PERMIT

RE: 55 (59) Washington Avenue – 013 I043 – B-4 – Signs for Electrical Wholesalers – permit #09-1134

59 Washington - Permit #09-1134

Project: 1561R1
Banners and Wall Signs

Blade Sign

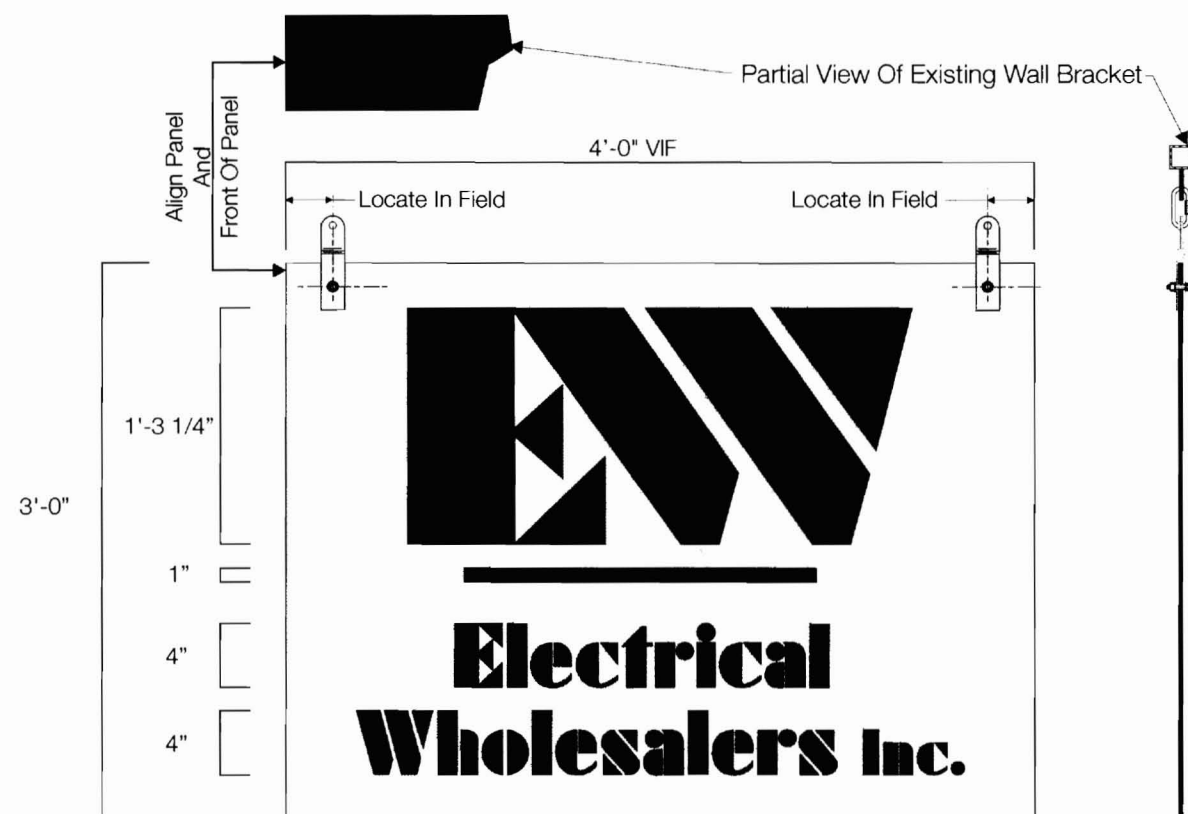
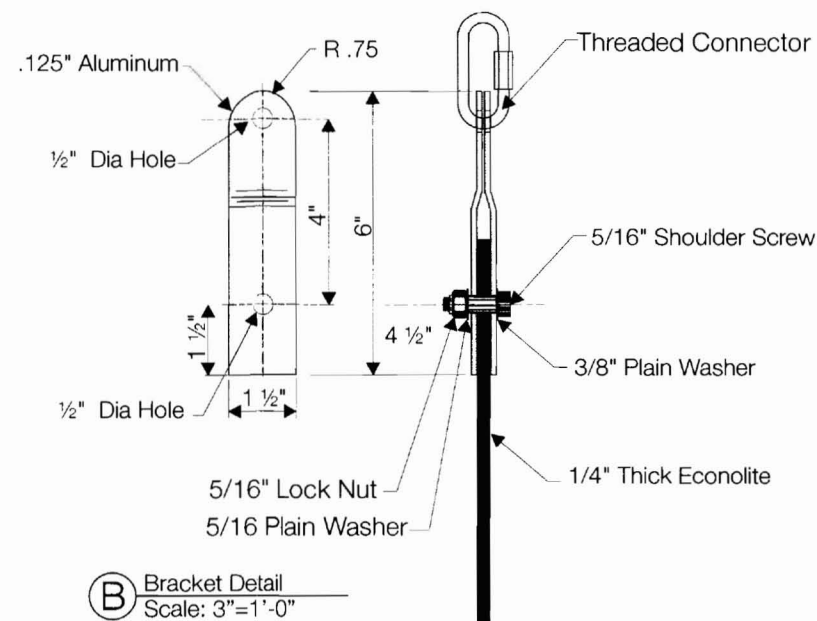
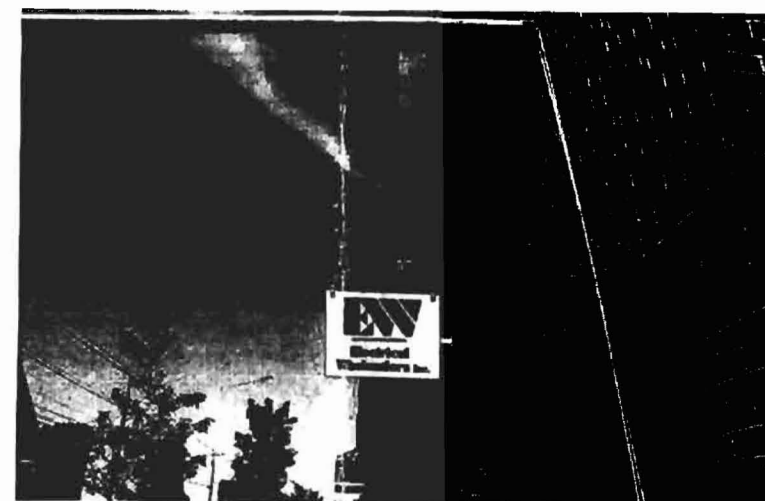
*This one sign that
is being permitted*

Illuminated Wall Sign

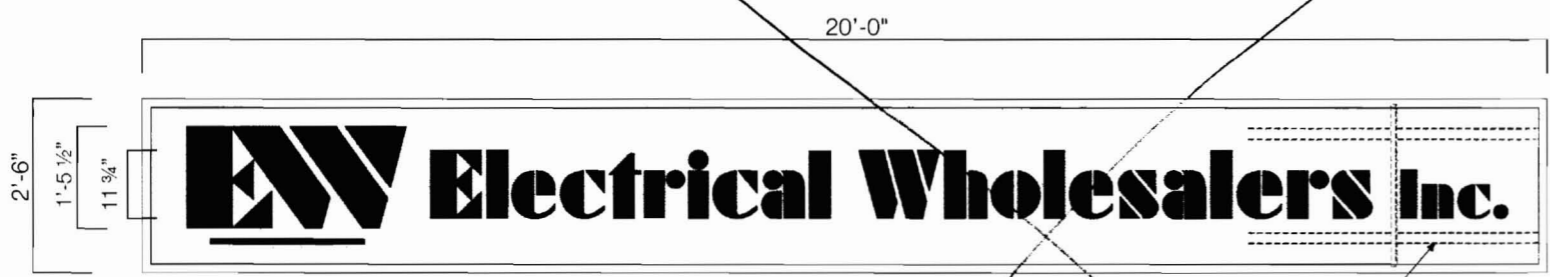
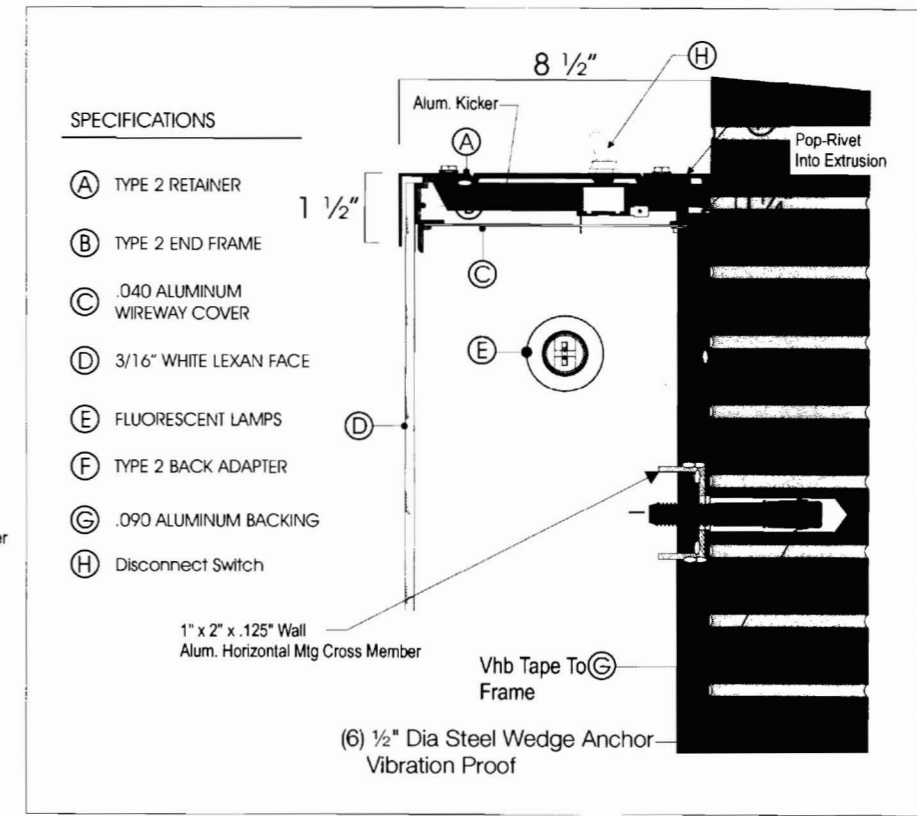
not allowed
not along part of
permit

not doing. / w/ drew. 11/13/09

wall sign - ~~$2.5 \times 20 = 50 \text{ ft}$~~
 ~~60 ft~~ - not allowed
not permitted

Approved By: _____
Date: _____
Illuminated Wall Sign

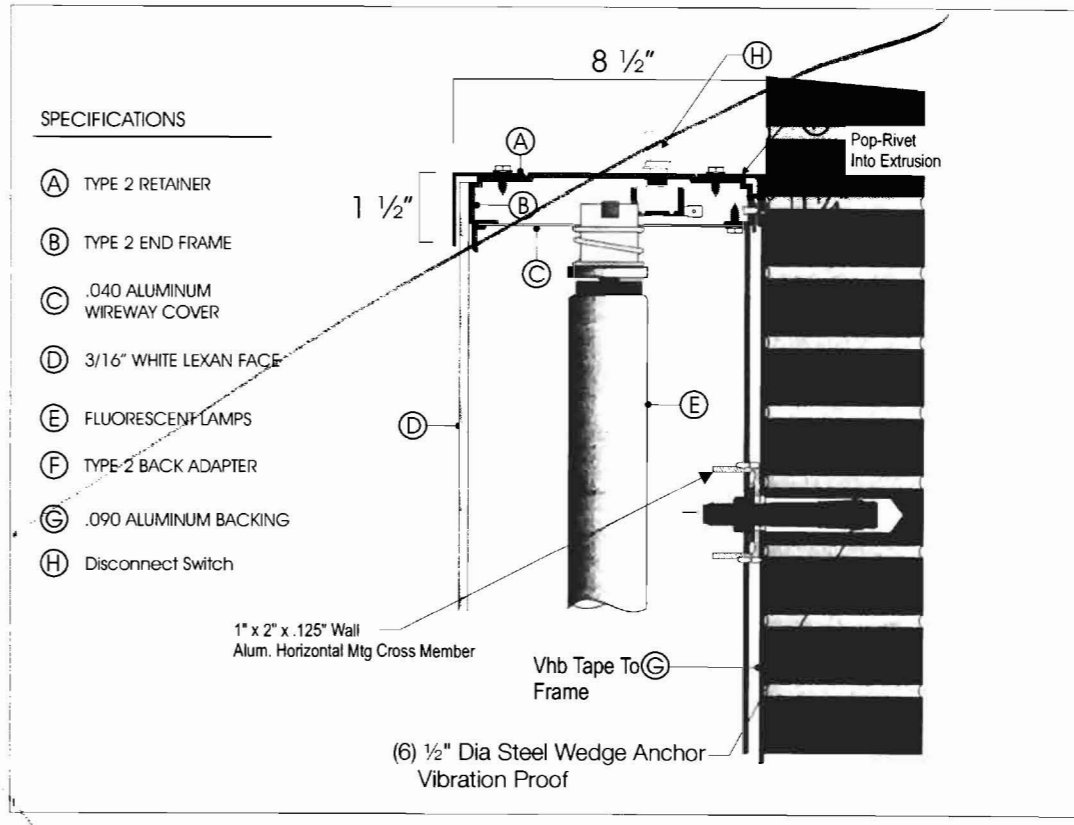
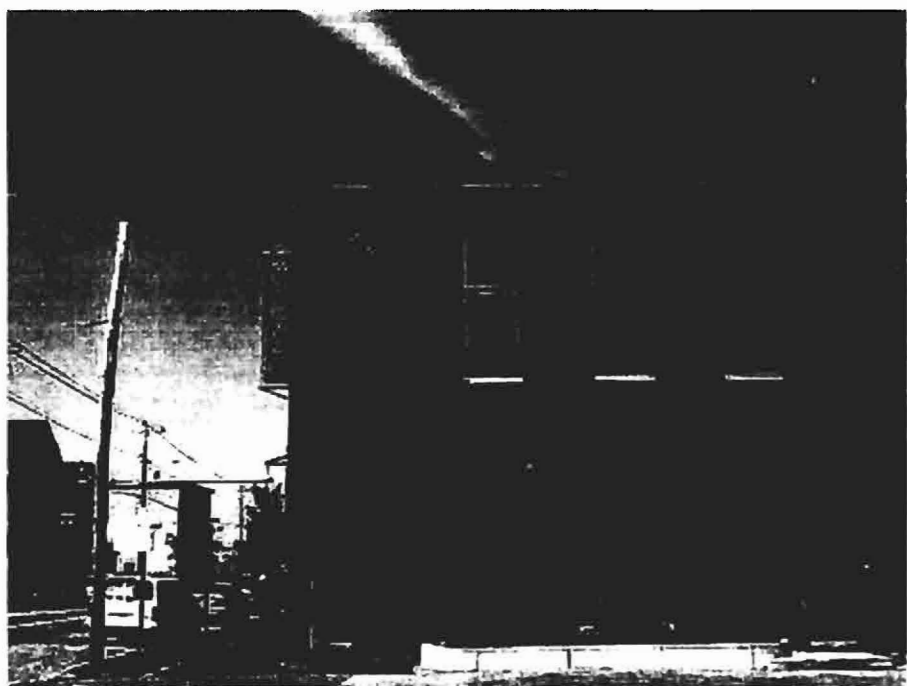
~~two signs~~ - only allowed one per front - only fronts on one street.
